Subject: Facility Survey of the White Pine County Courthouse, Ely, Nevada

FACILITY SURVEY

Name of Facility: WHITE PINE COUNTY COURTHOUSE

Date of Survey: September 13, 2007

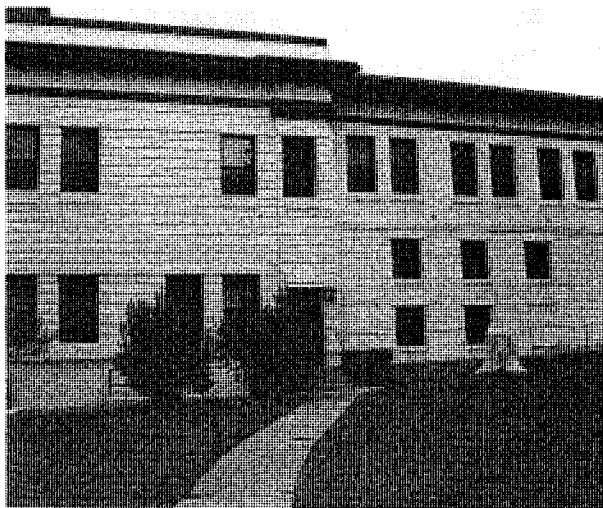
Problem: The exterior lighting is minimal, there is no exterior camera coverage, the courthouse windows lack proper tinting to prevent viewing directly into the offices, the shrubbery is not trimmed properly and the wells leading to the basement windows are not properly secured or monitored.

Recommendation: Additional lighting is necessary to properly illuminate 360 degrees around the courthouse with emphasis on all access points, all basement well areas, the grounds within a short distance of the courthouse and the walkways.

Monitored perimeter PTZ high resolution color cameras need to be placed around the courthouse to allow 360 degree coverage of the facility. (PTZ: Pan-Tilt-Zoom).

Window tinting or solar screens are necessary to prevent direct line of site into office windows during the day. Please understand these offer no protection at night, so all offices should keep their interior blinds at an oblique angle at all times.

Shrubbery covering 1st floor windows

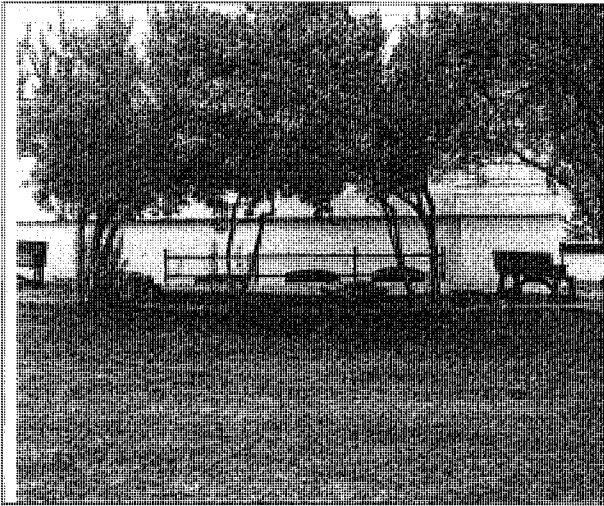
Shrubbery can easily shield someone so the shrubbery pictured should be trimmed so it is 12" to 18" below the bottom of the window frame. In the 3rd picture shrubbery works to your advantage by blocking the view into the windows without shielding someone at ground level, just make sure the ground level growth remains trimmed at all times.

Basement window wells surround the facility

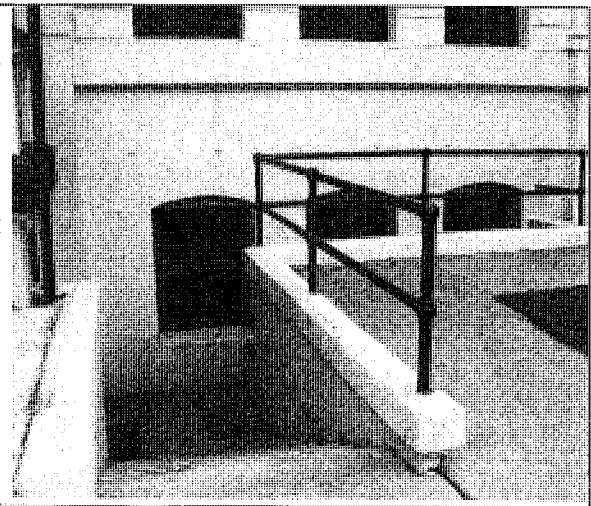
The basement window wells around this facility are wide open and can easily conceal an intruder. This area should be enclosed and access by hard key or card key ingress only and a push-bar egress for emergency exit. Any intruder will most likely access this area first so this area must be monitored closely through video and proper lighting.

Campton Street South of Courthouse

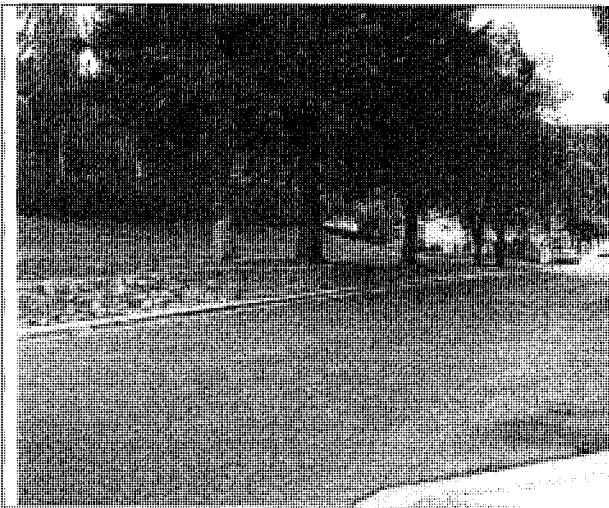
Problem: As you can see in the photos below there is no buffer zone between the facility and Campton Street and cars are allowed to park within close proximity of the courthouse.

Recommendation: This section of Campton Street should be blocked off to prevent normal traffic and parking near the courthouse; the area to the left has an open area which could be converted for additional parking and the wall pictured could be reinforced as a blast wall to protect from anyone parking a car in the lot with lethal intentions.

Gap between prisoner sally port & office

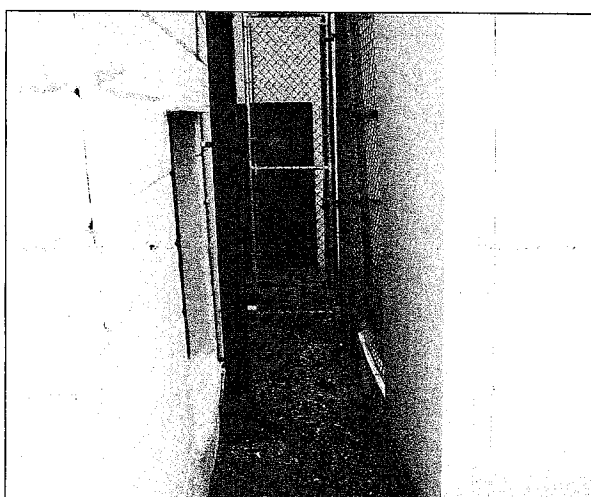
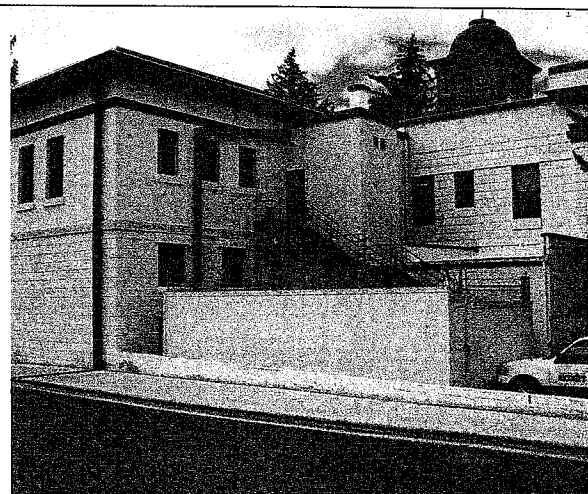
Problem: The first photo shows an open area between the prisoner sally port area and an office window; this area should be sealed to prevent public access and bollards installed to prevent a vehicle from accidentally crashing through the chain link fence and entering the office area.

Recommendation: This prisoner sally port should be replaced with a proper and secure facility for prisoner movements. A cement foundation enclosed with secure walls and roof with remote access for the prisoner vehicle rollup gate. The enclosure should also allow direct access to the prisoner ingress/egress courthouse door pictured below. This secure area should have a wall mounted duress alarm and be monitored via a video link. Both the prisoner vehicle roll-up gate and prisoner courthouse door need to be electronically activated from a remote location; transporting officers should never possess keys to either of these doors. An entry control package will be necessary for the monitoring station to have visual and oral communication with those who wish to enter the prisoner sally port area.

Prisoner sally port located on Campton St.

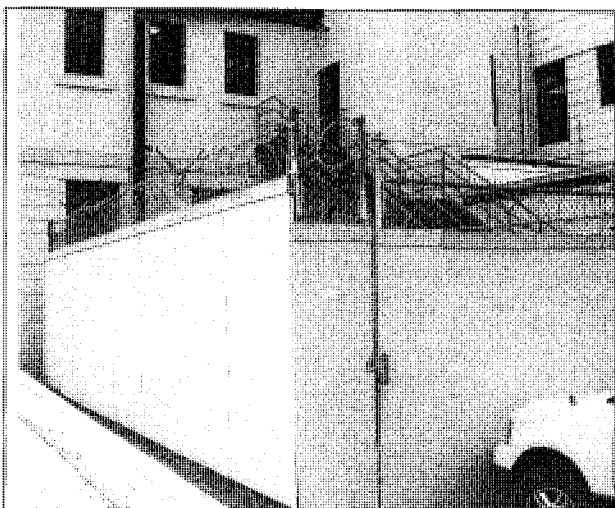
The other photos show the prisoner sally port which fails to meet minimum security standards. This sally port has no foundation, consists of standard chain link fencing with pad locks and the overhead area is exposed. The exterior prisoner movement area is easily compromised and has no camera coverage or duress alarm in place.

Standard pad lock and no covering

Stairs and lower rooftop lead directly to Judicial chambers window

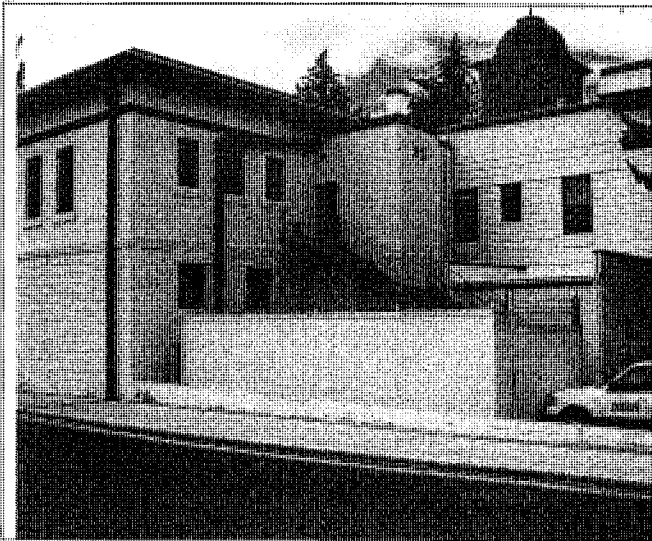
Problem: Open access to the areas pictured below. The gap between the stairs and prisoner sally port is wide enough for personnel to move through allowing access to prisoners and the basement door. The lower roof top leads directly to a judicial chamber window.

Recommendation: This area should be secured and monitored as well to include the grey utility cabinet. Public should not have access to this area and camera monitoring should be dedicated to the small roof top and the exterior basement and 2nd floor doors. The door pictured in the bottom left photo should be encased as part of the prisoner sally port area

North main entrance

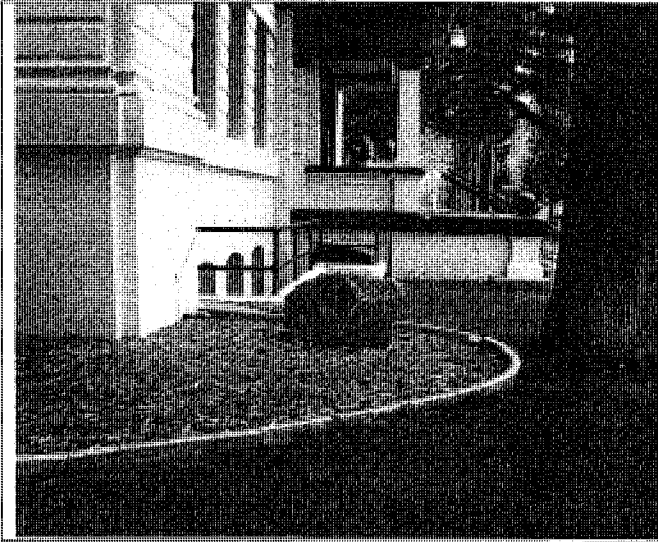
Problem: The entrance offers no protection for this facility or its employees and visitors, nor is it large enough to install security screening devices. Employees are not screened nor is there space to install security screening equipment at the west or south entrances. Also the west entrance does not meet ADA statute requirements.

Recommendation: The front entrance needs be expanded north and widened with a vestibule to accommodate a security screening station and modified to meet ADA statute requirements. Two sets of double doors are necessary, one for ingress and one for egress and another entrance door that meets ADA requirements. Bullet resistant glass panels should be installed to incase the front and side areas of the screening station. The screening station should consist of two magnetometers and at least 1 *Cat Scan machine. The screening station manpower should be no less than two security personnel for light volume and three personnel for high volume times. This allows at least one security officer to observe those approaching and those waiting to be screened while the other two concentrate on properly screening all who enter.

To enhance facility security, a duress alarm and monitor should be located at the screening station to monitor the immediate area outside the vestibule area; which provides timely warning to your first line defenders.

South side 2nd floor access

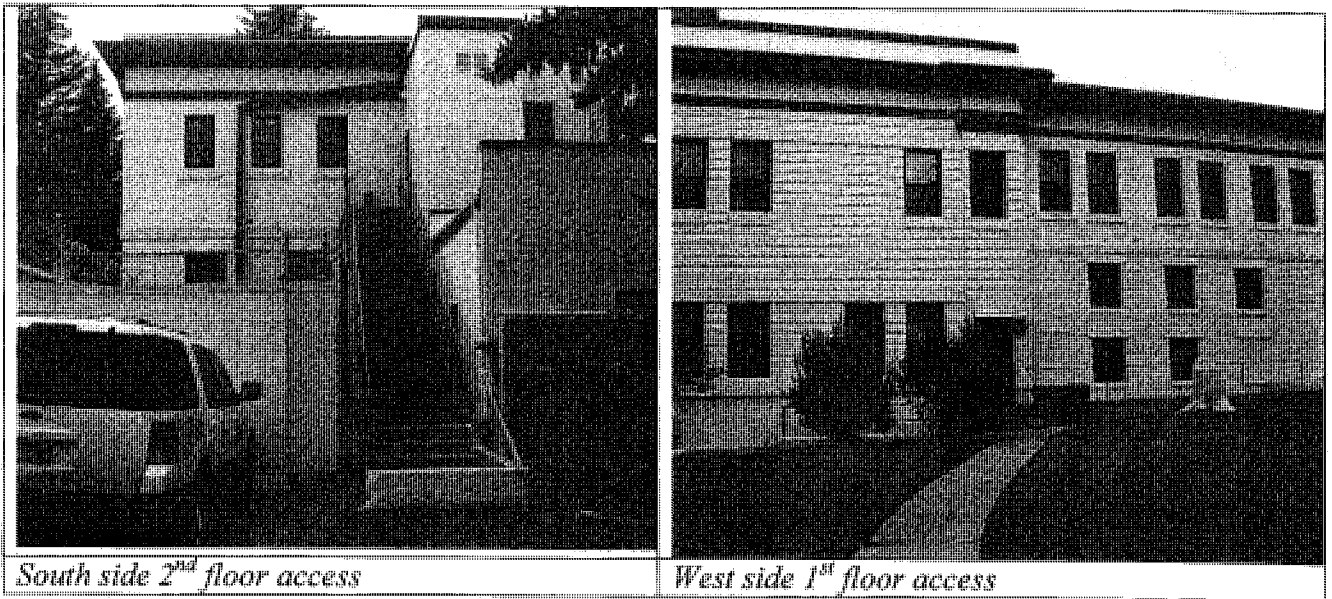
Problem: This area is wide open to the public with no camera coverage and the lighting is below minimum standards for security access points.

Recommendation: The south 2nd floor entrance or west 1st floor entrance should be for judges only and the door they use should be based upon the close proximity of their assigned parking spaces. The judges' entrance should have proper lighting and monitored digital recorded camera coverage.

If the south stairs become the judicial access point this area should be properly secured and monitored with siding along the south railing.

I would recommend when you build a proper prisoner sally port to also encase the stair area to provide judges extra security as they ascend/descend the rear of the building.

Prisoner seating area

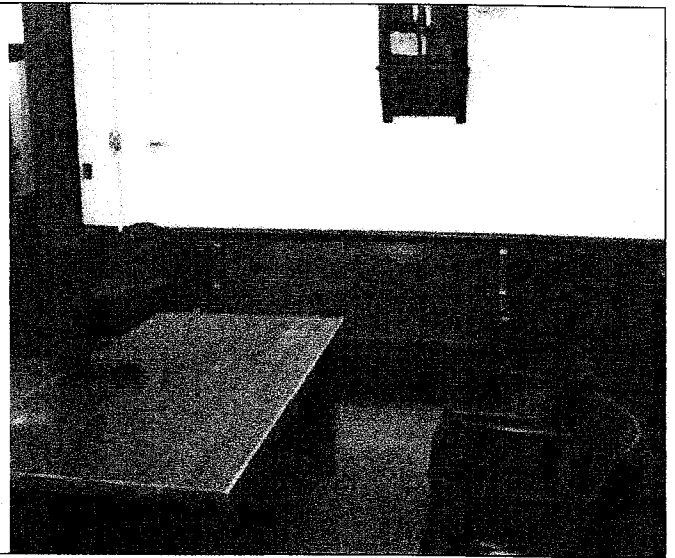
The prisoner seating location is very antiquated and is not suitable for state maximum security prisoners. This area should be encased since it is positioned so close to the gallery and except for trials all prisoners should remain in full restraints.

Light switches should be key controlled

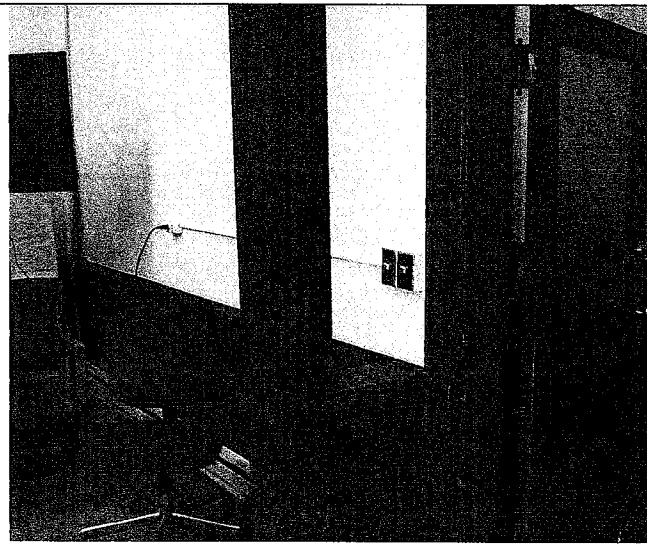
The interior courtroom light switches are accessible and can be easily turned off to create havoc during courtroom proceedings. No security cameras present, no ballistic material is encased in the

The courtroom lighting should be key-controlled to prevent anyone one from manually darkening the courtroom. All exposed electrical and plumbing lines need to be encased in the courtrooms and throughout the courthouse. Exposed plumbing and electrical lines make it to easy to tap into or sabotage for diversionary purposes.

Plumbing & Electrical lines should be encased

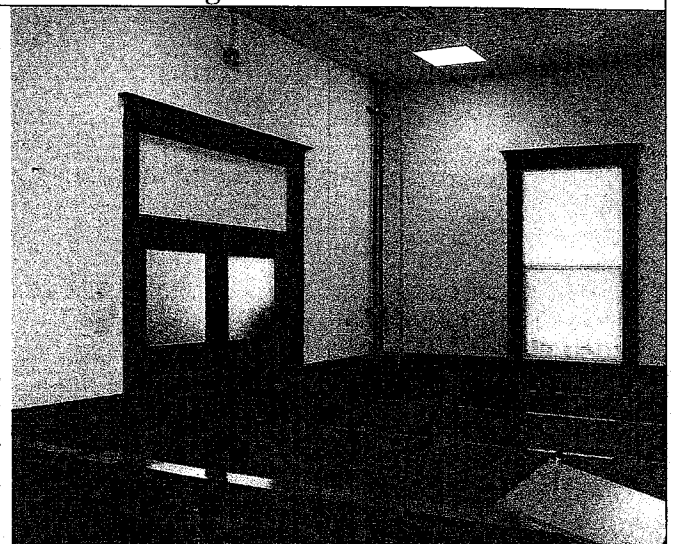
judge's bench, windows provide an open view into the courtroom and electrical and plumbing lines are exposed on the outside of the walls.

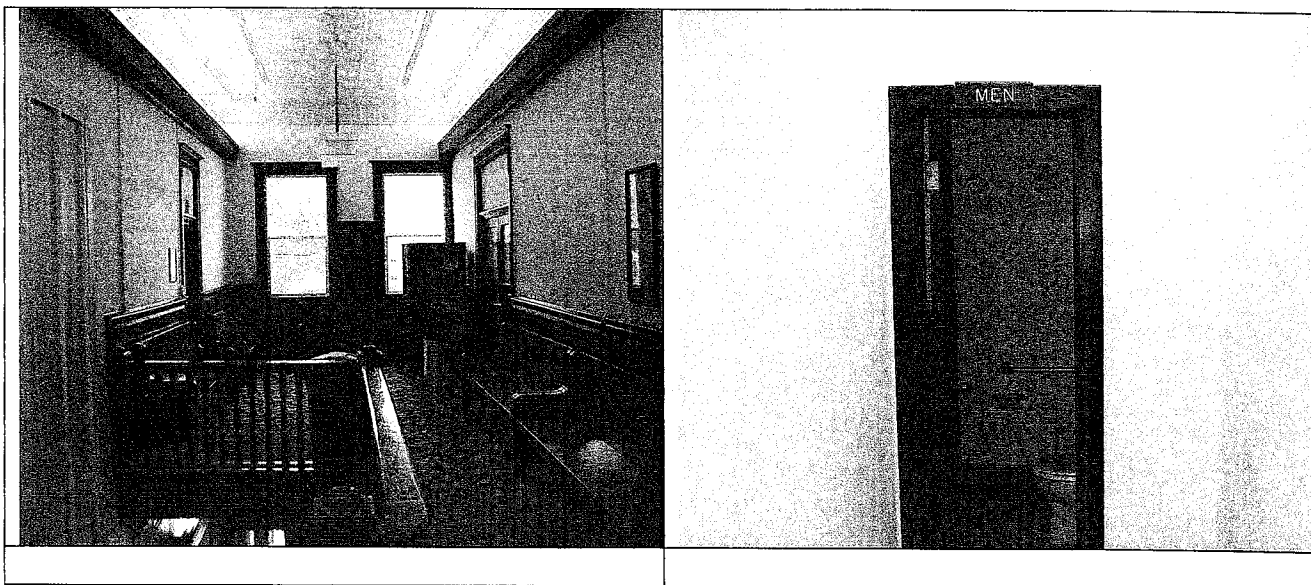
Problem: The common areas pictured below are used by everyone appearing in court. This small area must accommodate jurors, witnesses, attorneys, defendants and their family and friends; prisoners are also escorted past this same area.

The windows in this area have no coverings and allow direct viewing from the exterior.

Recommendation: If a new facility is not an option I would recommend moving some county offices out of the courthouse so a jury lounge and a public waiting area could be built. I also recommend that restroom facilities be built so the judges and court family personnel are not sharing with the public. The jury lounge should also have it own restrooms so jurors can maintain their distance from the public. The security integrity of our jury system is based on jurors having little or no contact with trial personnel before and during proceedings, which in this case cannot be met and falls below minimum security standards.

The windows should have an exterior coating and the interior should also have coverings to prevent direct line of sight in to the waiting area.

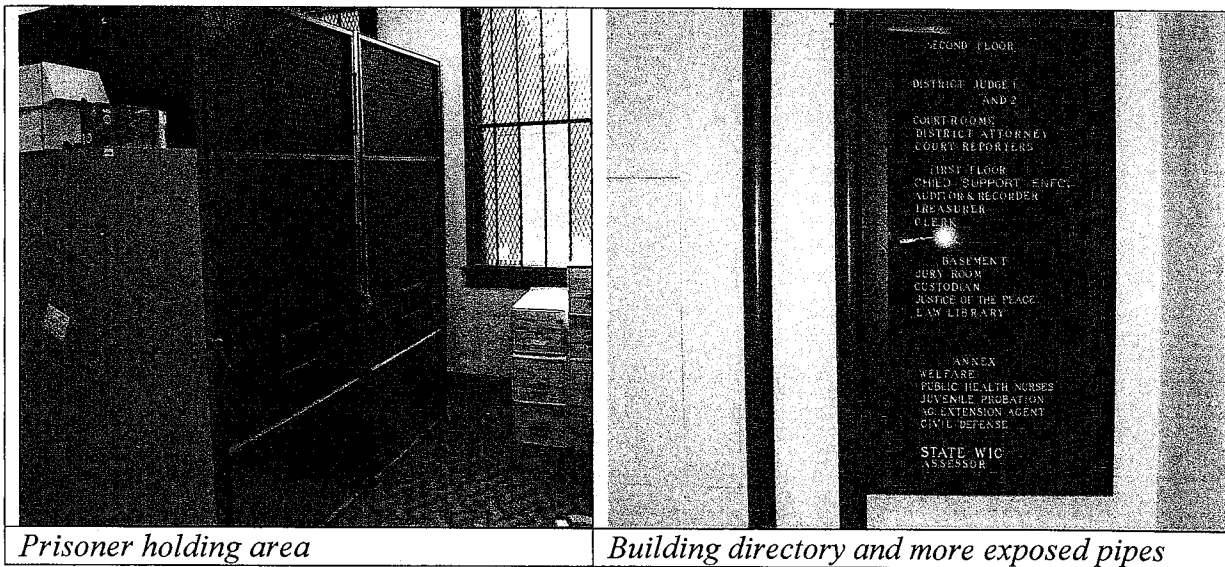
Problem: This facility is not designed or adequately equipped to handle state high security prisoners. Manpower used to handle prisoners in this setting is below minimum standards and poses a direct threat to all court family personnel and visitors.

The building directory is posted in the rear of the building where prisoners wait for the public elevator; this provides them information to the building layout and tenant information. The pipes and electrical lines are a continuing issue throughout the facility.

Recommendation: A major re-model to include prisoner holding cells with proper facilities in place and which also allows direct access into the courtroom without traveling through a public area. A duress alarm should also be installed for law enforcement personnel in the prisoner holding area.

The building directory should be located towards the front of the facility, away from prisoner viewing and the pipes and electrical lines covered to prevent damage by prisoners.

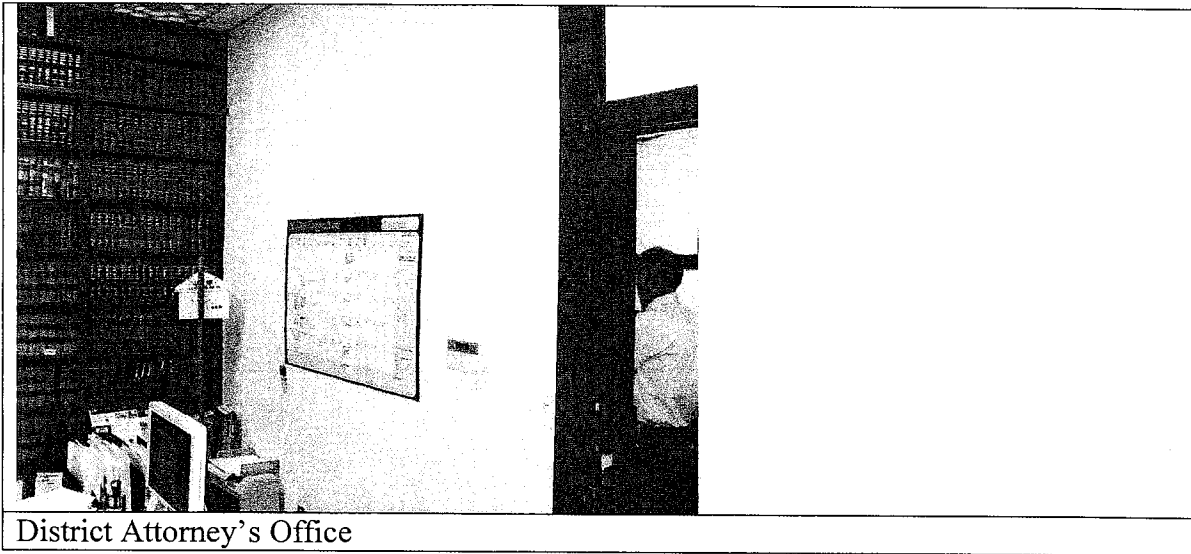
Problem: The DA's Office is open to the public with only one duress alarm in place. There is no emergency lighting and no access control measures in place. This office can handle up to \$2,000 and is kept in a hand carried lock box.

Recommendation: The office door should be a solid core door equipped with a MedCo type lock. The wall pictured with the calendar should be converted to a secure counter top with bullet resistance material and glass. Emergency lighting should be in place and two additional duress alarms installed at the DA and secretary desks. A floor mounted safe should be used to store all monetary items.

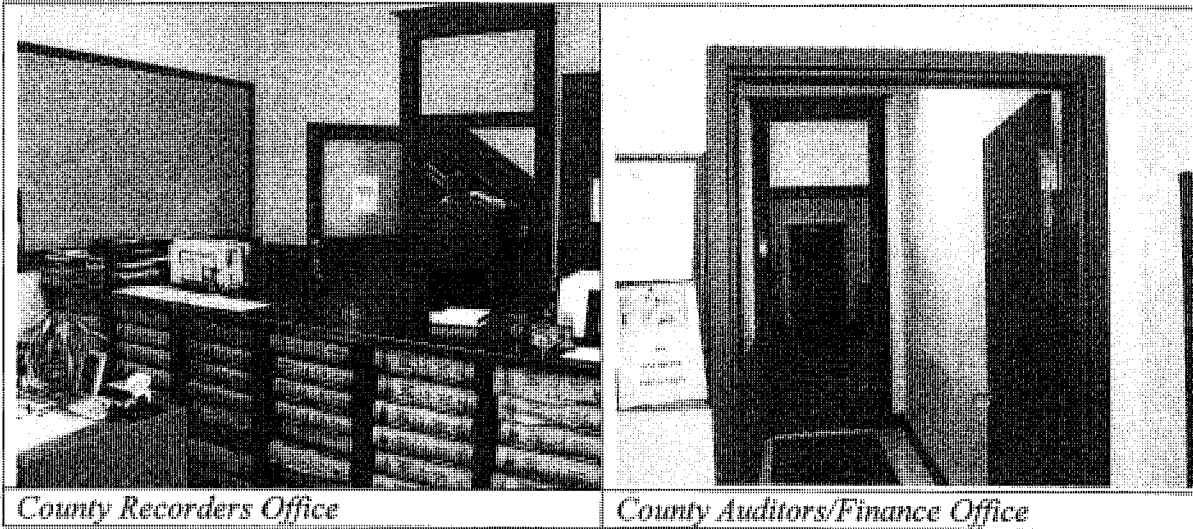
Problem: The jury room is small and confined and the windows allow open viewing into and out of the jury room; there is no emergency lighting in place.

Recommendation: The windows allow for distractions and communication both ways which could defeat the security integrity for a trial. The windows should be frosted to prevent jurors from being distracted and external coverings to obstruct viewing from the outside. Emergency lighting should be installed.

Public 1st Floor Area

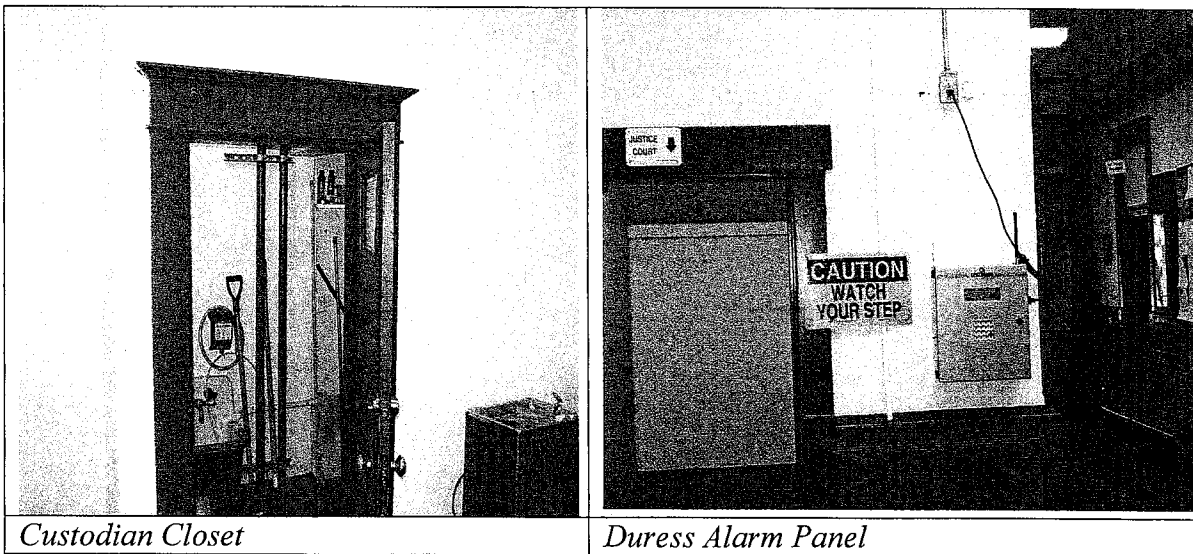
Problem: These areas are unsecured and are located in public space.

Recommendation: Secure all these areas with reinforced cabinets and proper security locks. All the exposed plumbing and electrical wiring throughout the facility is an issue onto itself, but unsecured items like these can be addressed immediately.
